UNITED STATES ENVIRONMENTAL PROTECTION AGENCY
REGION IX
75 Hawthorne Street
San Francisco, CA 94105

Re: April 1, 2008 Clean Water Act Inspection

NPDES COMPLIANCE EVALUATION INSPECTION

NPDES Permittee: American Samoa Power Authority
Facility: Satala Power Plant
P.O. Box PPB, Pago Pago, Tutuila Island, American Samoa
(NPDES Permit No. AS0020044)
Receiving Water: Pago Pago Harbor
Date of Inspection: April 1, 2008

Photo #4: Fuel Farm Sump Drain Lay-out
Taken By: Greg V. Arthur
Date: 04/01/08

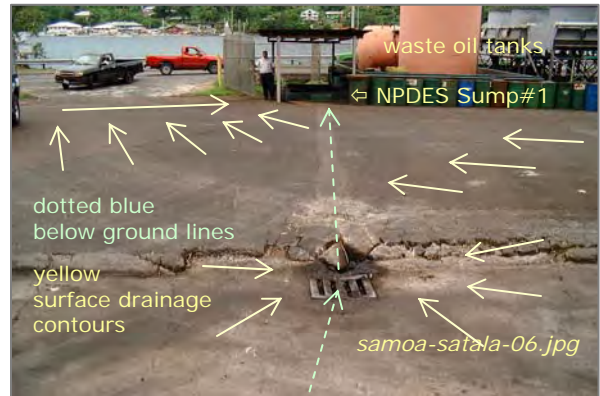
Fuel Tank Farm – Two 24,000 gallon diesel tanks are installed behind concrete block secondary containment walls. The fuel tanks are power washed every three weeks. Storm water run-off and wastewaters captured within the secondary containment drain to a small sump located in the center, inside, and against the front wall. This sump drains by buried line to a central sump drain located at the edge of the truck unloading area outside of the fuel farm. The central sump drain discharges by gravity through underground pipe to NPDES Sump #1. The buried drain line from the sump inside of the fuel tank farm containment is valved, and was found in the open position during this inspection. A lube oil tank is located outside of and adjacent to the fuel farm, without secondary containment but housed within a steel framework super-structure. See Photos #2 and #4 in Section 1.6 on pages 6 and 7.

Fuel Farm Tank Wash – ASPA indicates that the diesel tanks are power washed every three weeks with the tail waters drained through the valved drain to the main sump to the oil water separator irrespective of storm events. This tank wash water would be expected to entrain diesel, grime, and organic material.

- The valved drain line from the fuel tank farm containment sump to the drain lines leading to the eastern oil water separator should be operated in the normally closed position.
- The valved drain line from the waste oil storage containment to the eastern oil water separator should be operated in the normally closed position.
- The unvalved drain line from the curbed transformer platform to the western oil water separator should be retrofitted with a valve then operated in the normally closed position.
- Copper and zinc sources into the drainages should be identified and for each source, and additional best management practices and/or pollution prevention should be proposed.
- Contaminated groundwater seepages should be pretreated through a dedicated package oil water separator for discharge through the eastern oil water separator.

Photo #5: NPDES Sump #1 – Soapy Drainage
Taken By: Greg V. Arthur
Date: 04/01/08

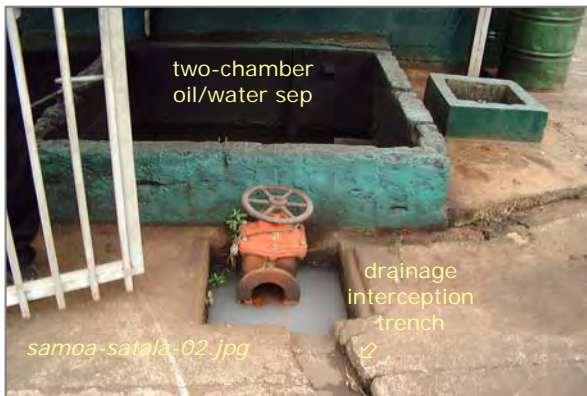
3 Sampling captures only storm water run-off and thus does not account for the process-related wastewaters generated irrespective of storm events. These process wastewaters include cooling tower spents, fuel tank farm wash, and truck wash down. Soapy process-related wastewater was found in the interceptor trench leading to the oil water separator.

Truck Wash – Cloudy wastewater that was said by ASPA to be from truck washing was observed in the interceptor trench. The pollutants in the truck wash are unknown at this time although it is likely to include alkaline soap and the resulting emulsified oils. Truck wash drains uncontrolled into the interceptor trench to the oil water separator irrespective of storm events.

- The NPDES permit should require impoundment of the process wastewaters (*cooling water spents, fuel farm wash down, truck wash down*) for discharge during storm events.

Photo #6: NPDES Sump #2 – Transformer Inlet
Taken By: Greg V. Arthur
Date: 04/01/08

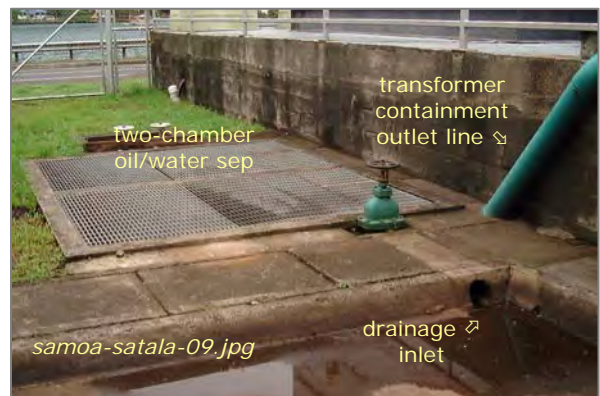
Transformer Platform – Transformers are installed over a vault box, adjacent to NPDES Sump #2. The platform is curbed to provide secondary containment around the transformers. However the containment is outfitted with an unvalved (and thus always open) drainage line into NPDES Sump #2. See Photo #6 in Section 1.6 on page 7.

The NPDES permit establishes a number of narrative prohibitions as the receiving water limits for Pago Pago Harbor. The facility drainages and drainage sources observed to discharge through NPDES Sump #1 and NPDES Sump #2 would be expected to be substantially free of color, odor, taste, visible floating materials, oils, turbidity, toxicity, or solid wastes, although the soapy wash waters found in the interceptor channel could impart some turbidity in the harbor. In order to reduce the risks of facility drainages adversely impacting the harbor, the drainage lines from the secondary containments for the fuel tank farm, the waste oil tanks, and the transformer platform, all should be operated normally closed to allow visual inspection prior to release to the sumps.
